SUNDRY NOTICES AND REPORTS ON WELLS

Corral Draw 10 #1H

OXY USA Inc. respectfully requests the following change of plans from the previously approved drilling permit. OXY proposes to drill a 7-7/8" pilothole to 5800' log (DLL/MSFL/DSN/SDL/GRL), plugback (see attached for procedure) and then kickoff horizontal lateral. The well will be drilled with a closed loop system (see attached for rig layout, BOP-5000#WP and C-144 CLEZ).

Corral Draw 10 #1H
Attachment – Proposed Pilotheole Plugback Procedure

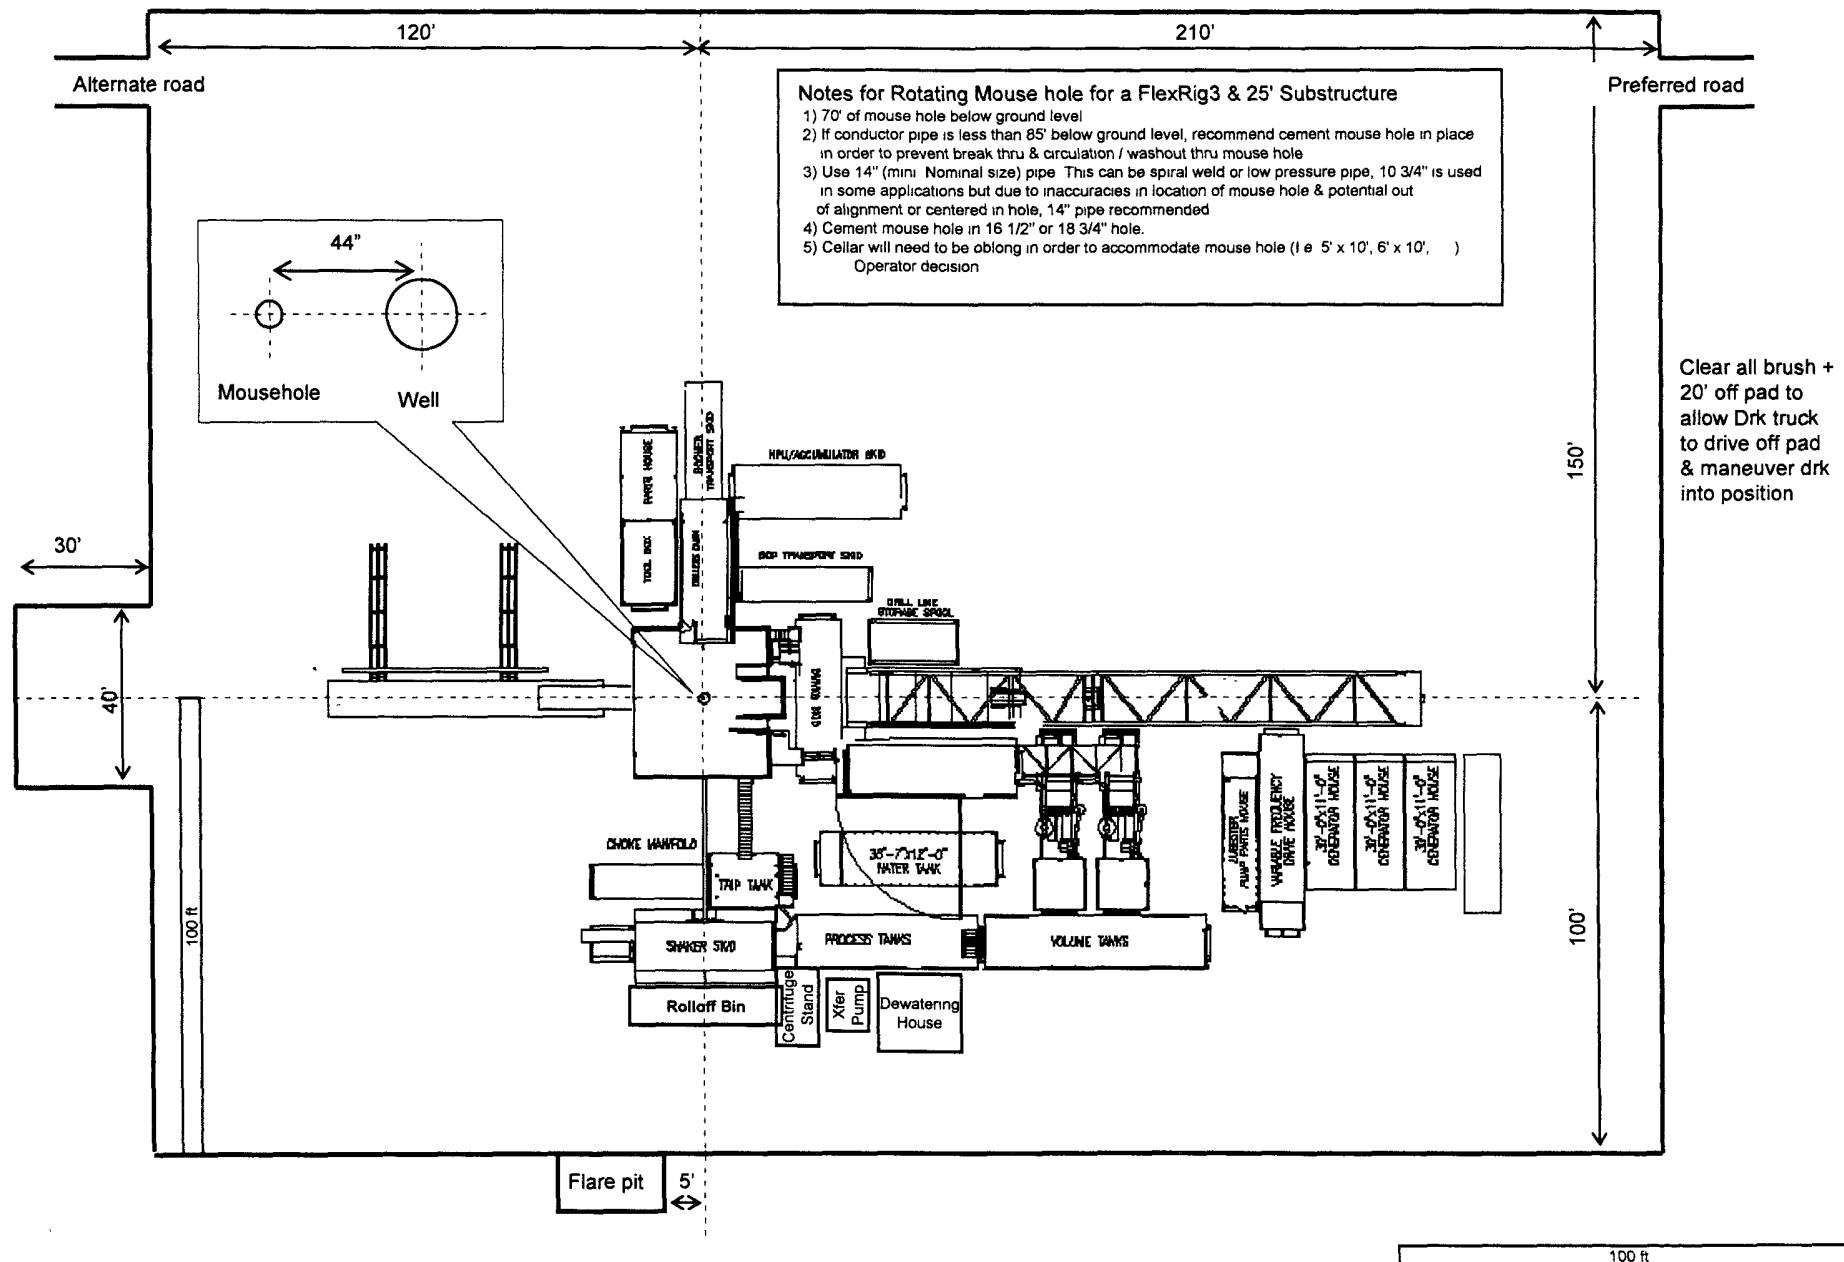
Plug 3: Set a Kick-off Plug from 5200 ft to 4760 ft

10M AND 15M CHOKE MANIFOLD EQUIPMENT - CONFIGURATION OF CHOKES MAY VARY
 [53 FR 49661, Dec. 9, 1988 and 54 FR 39528, Sept. 27, 1989]

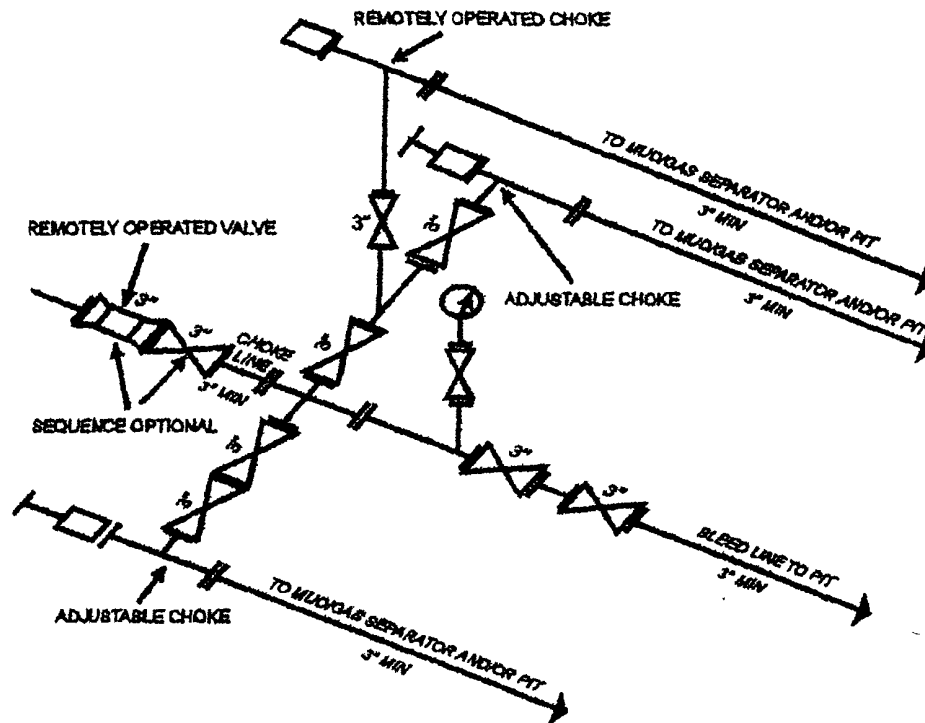
OXY also requests the following variance to the Pressure Control Equipment that was permitted and approved in the original drilling plan. OXY proposes to connect from the BOP outlet to the choke manifold a flex line that is manufactured by Contitech Rubber Industrial KFT. It is a 3" ID X 35' flexible hose rated to 10000psi working pressure. It has been tested to 15000psi and is built to API. Spec 16C. Once the flex line is installed, it will be tied down with safety clamps, certification attached.
